aiwa

SERVICE TECHNICAL INFORMATION

MODEL : TV-1402KE/2002KE/2102KE

SUBJECT : Part Number of EEP ROM (IC002/NVM3060)

Fig-1

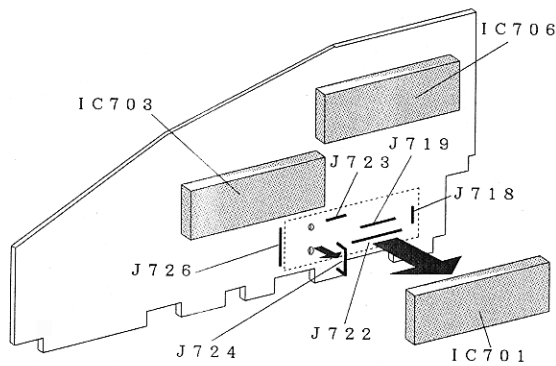
1. Remove IC701, IC703, and IC706. (See Fig. 1.)
2. Remove all jumper lines mounted under IC. (See Fig. 1.)

Under IC701:	J718/ J719/ J722/ J723/ J724/ J726	} Total of 22 lines.
Under IC703:	J746/ J747/ J748/ J749/ J751/ J752/ J792	
Under IC706:	J754/ J757/ J758/ J759/ J760/ J761/ J762/ J763/ J764

DIGITAL C.B (side with mounted parts)
As shown in the diagram, remove the ICs and then remove each jumper line.

Fig-2

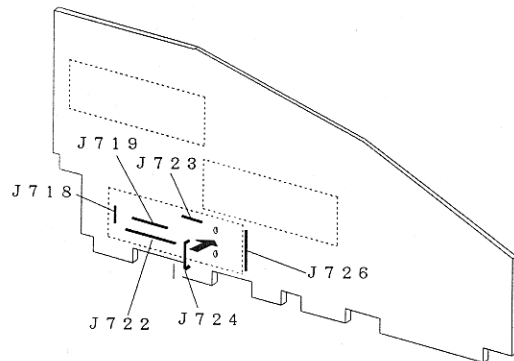
3. Attach the removed jumper lines to the pattern surface on the reverse side. (See Fig. 2)

DIGITAL C.B (Pattern side)
Attach the removed jumper lines to the pattern surface and solder. At this time, make sure that jumper lines are not too long that they protrude over to the side with the mounted parts.

X701 Waveform

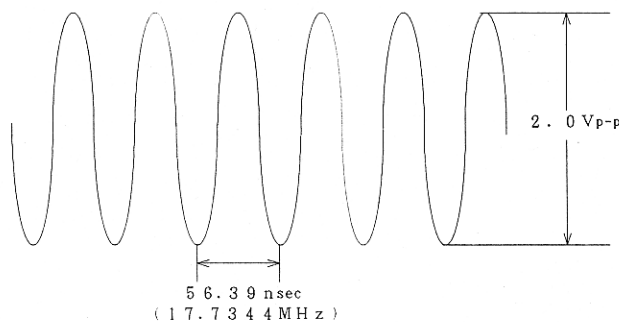
There have also been many cases of faulty X701s and faulty soldering. When repairing DIGITAL C.B, always confirm that X701 operates correctly. (See below.)

Note: Voltage of the observed waveform changes in accordance with input impedance and the input amount from probes and oscilloscopes used for measurements.

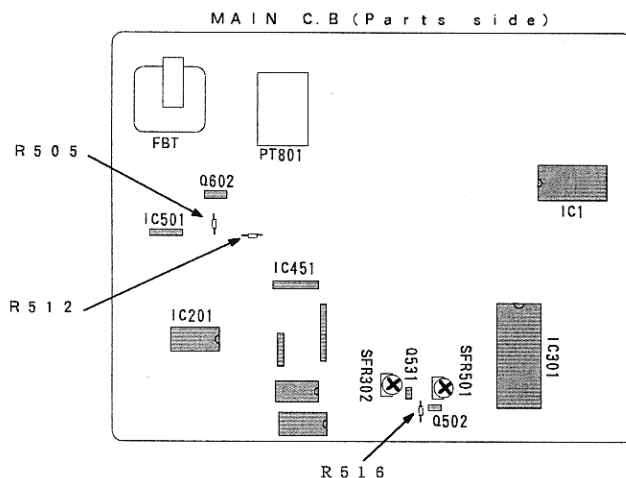
- MODEL : TV-A205 KER/TV-A145 KER
 SUBJECT : Horizontal line appears at bottom of screen
 SYMPTOM : The bottom portion of screen has vertical size compression, and a horizontal line appears at bottom of the screen due to degraded vertical linearity characteristics. (The symptom becomes recognizable after long-duration operation or under no-input status.)

- ACTIONS : Replace the three resistors shown below.

R505	R512	R516	
Existing	82K-1/8W	1.8K-1/8W	180K-1/8W (*)	Correct value is 180K-1/8W. "180-1/8W" in S/M circuit diagram is wrong.
	↓	↓	↓	
After replacement	39K-1/8W	1.2K-1/8W	270K-1/8W

Ref.	Part name	Part number
R505	RES, 39K-1/8W J	88-121-393-080
R512	RES, 1.2K-1/8W J	88-121-122-080
R516	RES, 270K-1/8W J	88-121-274-080

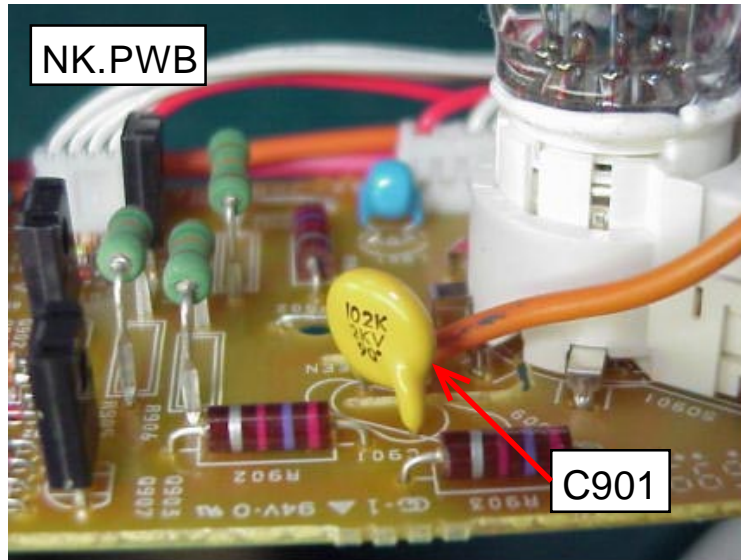
The screen voltage falls down due to an abnormality of the capacitor C901 thereby causing the screen to become dark.

Replace the capacitor C901.

*Always make sure to use the specified part because the manufacturer of this part has been changed.

Ref.	Parts Code	Description	Remarks
C901	87-016-037-060	CAP,CER 1000P-2KB	-

Method of discriminating between the microcomputer IC of different regional models

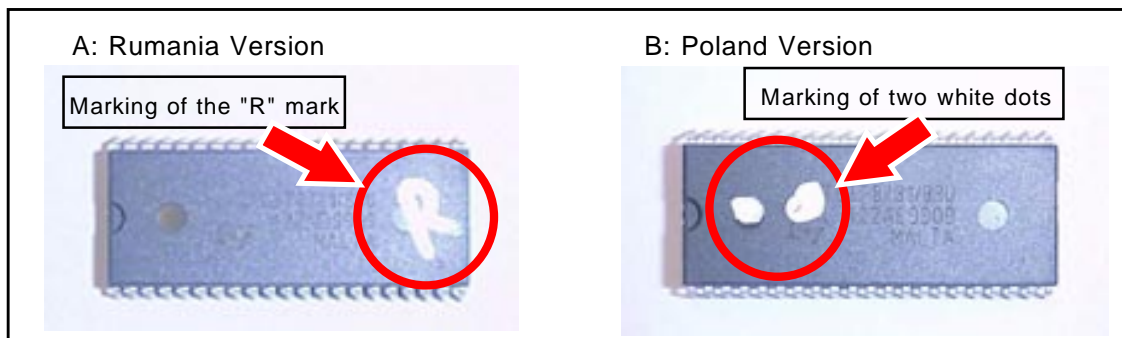
*Take care about the differences between the regional models.

A:IC, ST6387-OTP 6373	Rumania Version	The mark "R" is present on the top surface of the IC.
B:IC, ST6387-OTP 6331	Poland Version	There are marks of two white dots on the top surface of the IC.

Ref.	Parts Code	Description	Remarks
IC1	87-JB1-626-010	IC, ST6387-OTP 6373	for Romania version
IC1	87-JB1-627-010	IC, ST6387-OTP 6331	for Poland, Czech, Slovakia

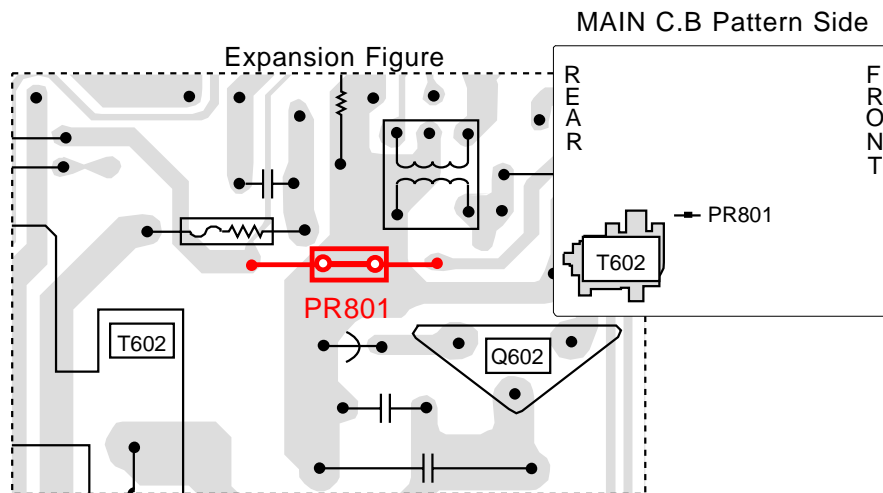
No power due to open IC PROTECTOR (ICP,PR 801) caused by a rush current.

Replace the IC Protector (PR801 1.5A)with one that has higher current capacity(4A).

Ref.	Parts Code	Description	Remarks
PR801	87-A90-094-080	PROTECTOR,4A 491SERIES 60V	-

Fig.3 Distinction switch set up data for each model

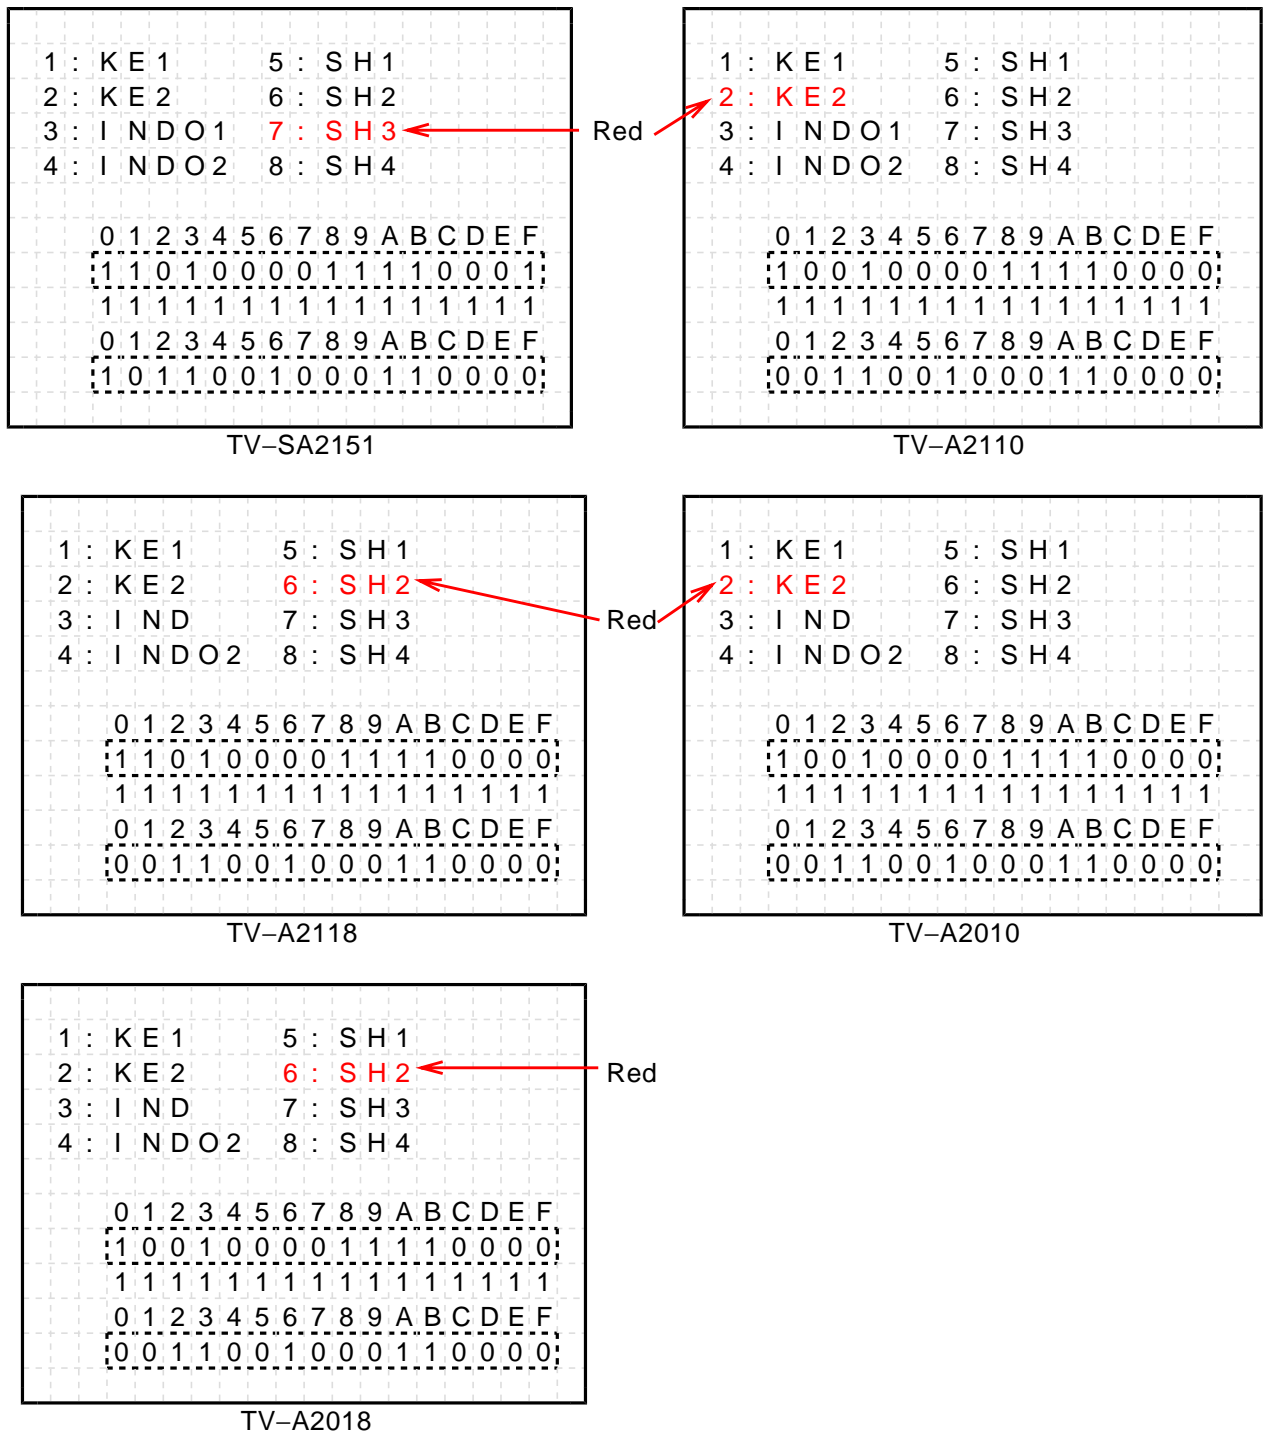
4. Check to see if the data of address 0-1F match the Fig3 (next page) or not.
If not, amend them as follows:
CHANNEL UP/DOWN Select appropriate data (selected data appear in red)
VOLUME UP/DOWN Change value (0 or 1)
5. After data input and/or confirmation is completed, Press TEST key to go back to the AGING mode.

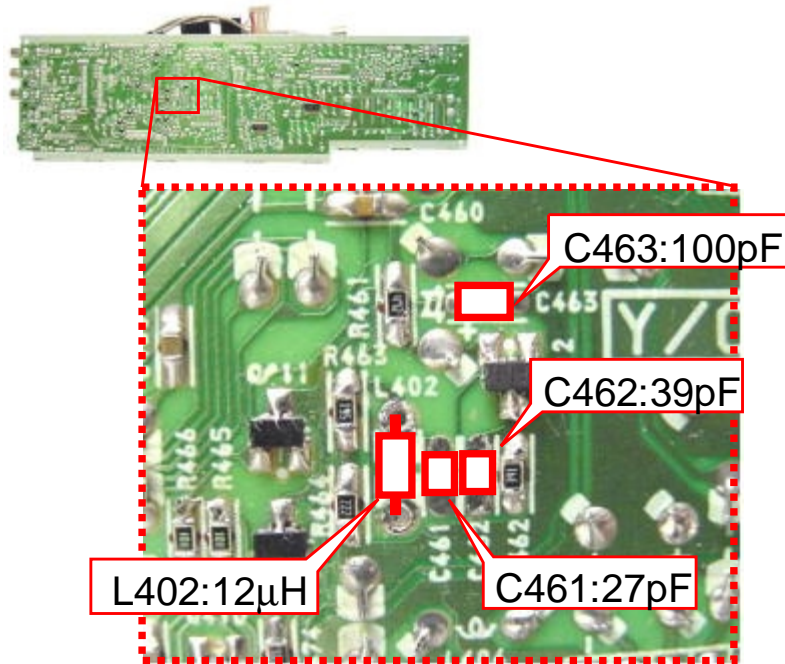
A vertical line may appear on TV screen when VCD player or DVD player is connected to input terminal for playback.

Add a filter (when fitting L402, remove jumper wire).

Ref.	Parts Code	Description	Remarks
-	SV-T00-117-01J	KIT,TV-F2100/F2500 V NOISE	-

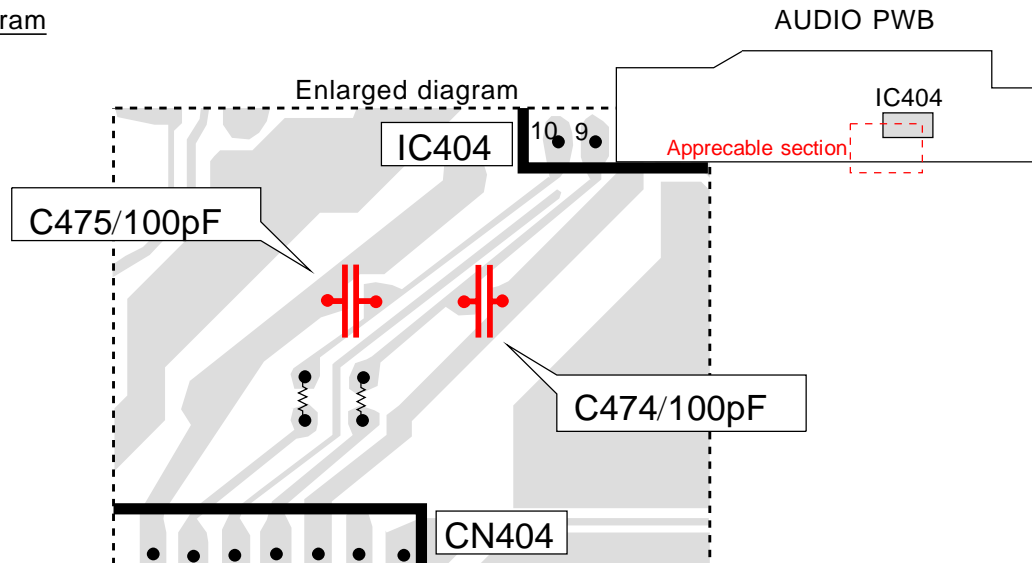
Noise enters into the data line(SDA/SCK) of IC404(volume controller) and causes the following symptoms.

Add a capacitor to the data line(SDA/SCK) of IC404(volume controller) and compose a noise filter(Lands are available).

Ref.	Parts Code	Description	Remarks
C475,C474	87-010-322-080	C-CAP,S 100P-50 J CH GR	-

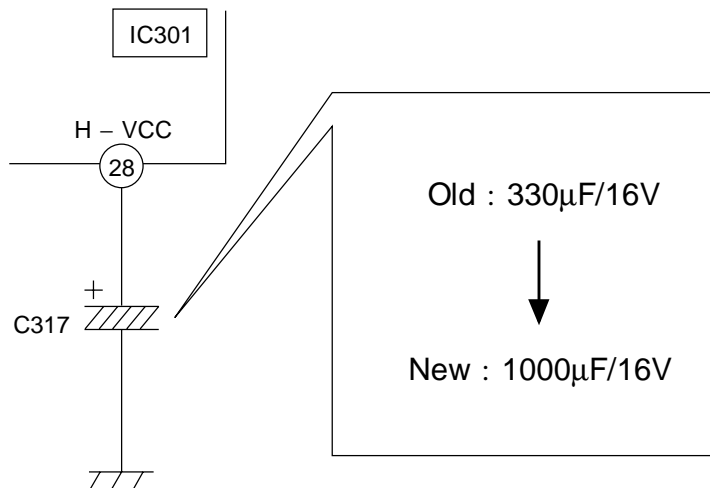
Black marking appear as shown below.
Appearing point defers according to the set.

1. Replace C317(330μF/16V) to 1000μF/16V(87-A10-730-080) regardless the symptom.
2. If already CRT burned in, replace to new CRT.

Ref.	Parts Code	Description	Remarks
C317	87-A10-730-080	CAP,E 1000-16V SMG	-

Fig1

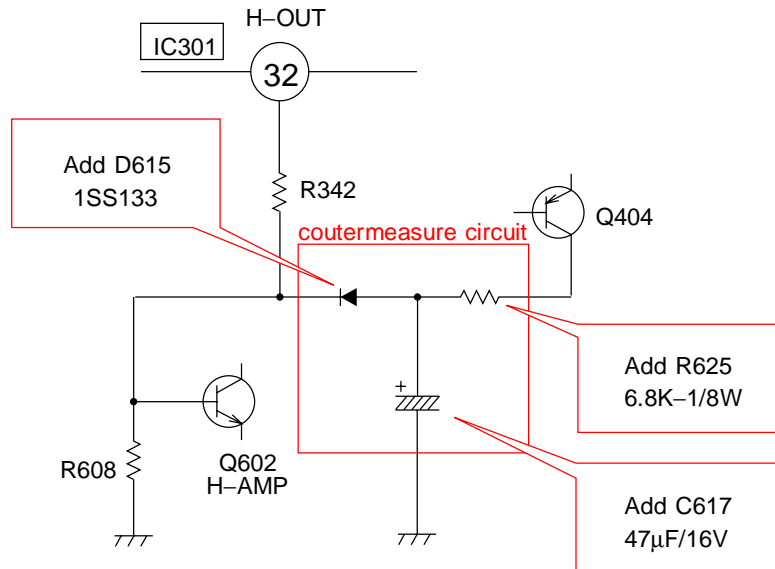
1. Replace Q601 after confirming PR801 is open.
2. Connect condenser, diode, resistor, and wire according to the drawing 1.

Be care to the direction of diode and condensor.

WIRING

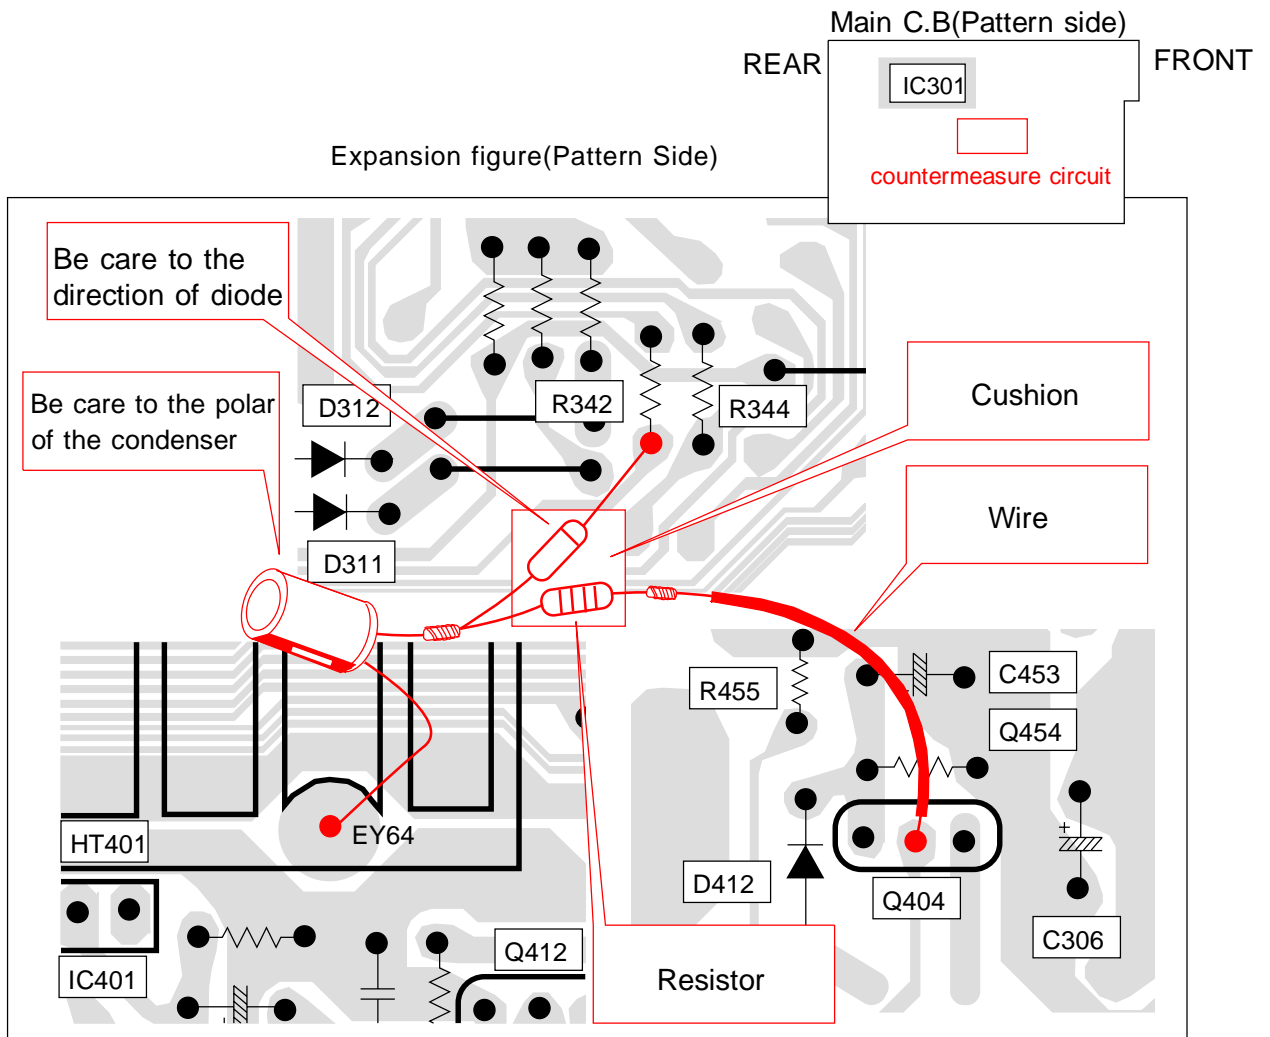
3. Attach the circuit 2 to the rear of main board.(Refer next page)

Be sure to glue (KE-3490) after putting the semiconductor to the board.

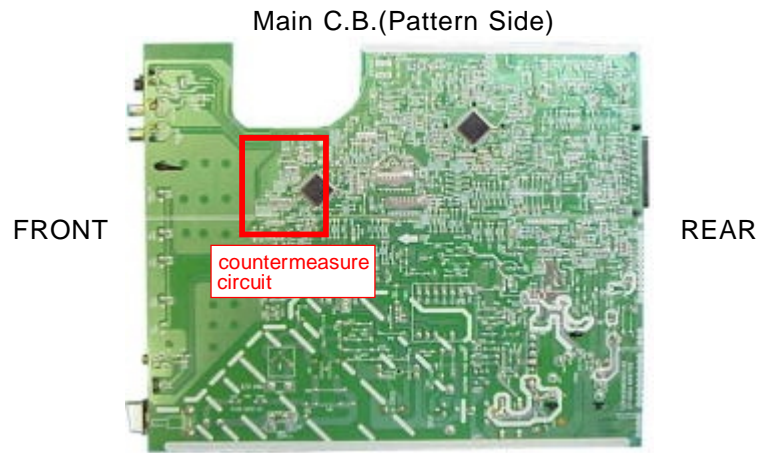
It may happen that " OSD does not display, standby LED does not light " as the flux causes to change the capacity of CC709,CC723.

By replacing the condenser CC709,CC723 from chip type to AXIAL type, the effect of flux reduces.(Please refer the next page for actual installation)

Ref.	Parts Code	Description	Remarks
CC709,CC723	87-A11-073-080	CAP,TC U 22P-50J CH

1. CC709 improvement point

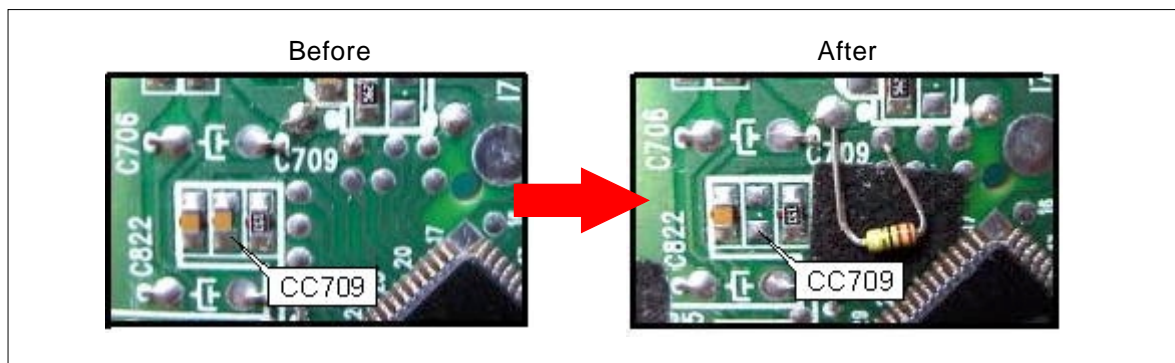
Remove chip type condenser.

Attach adhesive cloth or cushion and put AXIAL type condenser.

2. CC723 improvement point

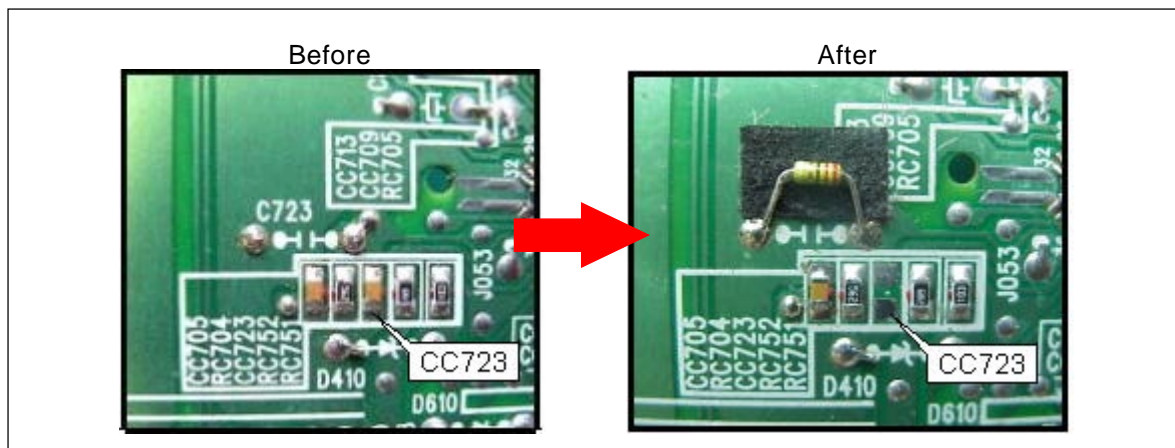
Remove chip type condenser.

Attach adhesive cloth or cushion and put AXIAL type condenser.

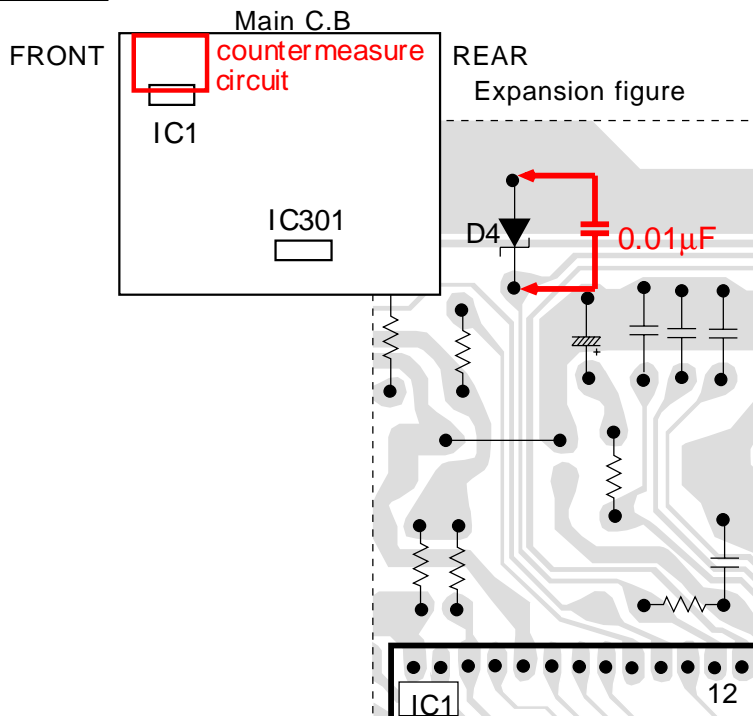
Power may off automatically due to the malfunction of 12 PIN (EXT terminal) of IC 1(micro processor)
In this case, please take the following corrective countermeasure.

Micro processor may occur malfunction due to the noise of EXT terminal.
To prevent malfunction, attach the condenser 0.01 μ F parallel to D4 on the reverse side.

*Be sure with glue after attaching the condenser.

Ref.	Parts Code	Description	Remarks
-	87-A11-132-080	CAP,TC U 0.01-50 K B	-

Pattern diagram MAIN PWB(Pattern side)

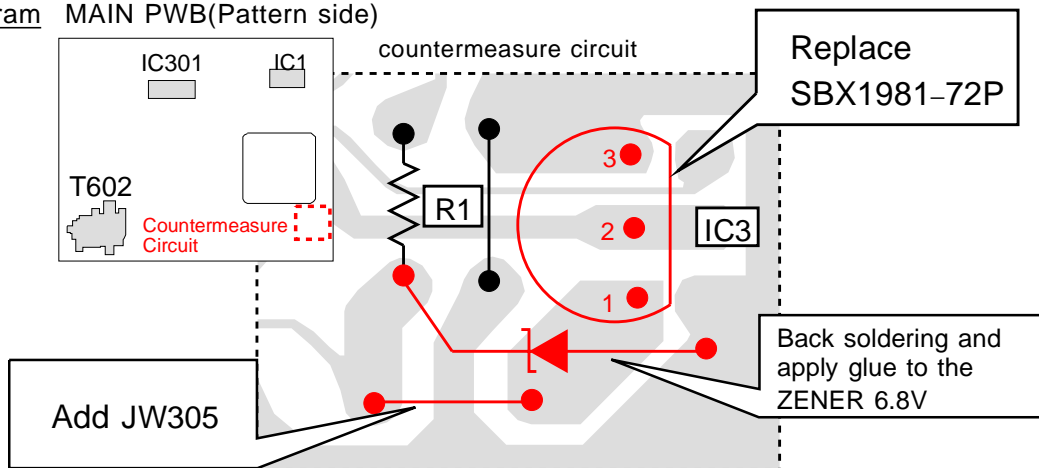
Due to malfunction of sensor part of remote controller(IC3), it may does not work properly.
In this case, take the following corrective countermeasure.
(Corrected set is dotted at the right side of serial No.)

1. Replace IC3 from GP1U281Y to SBX1981-72P.
2. Add JW305 following the drawing(land exists).
3. Back solder ZENER,UZ6.8BSC following the drawing.
Glue(KE-3490) on the parts.
4. Put the dot mark at the right side of serial No. after countermeasure.

Ref.	Parts Code	Description	Remarks
-	87-A40-754-080	ZENER,UZ6.8BSC	-
IC3	87-A91-538-010	RCR UNIT,SBX1981-72P	-
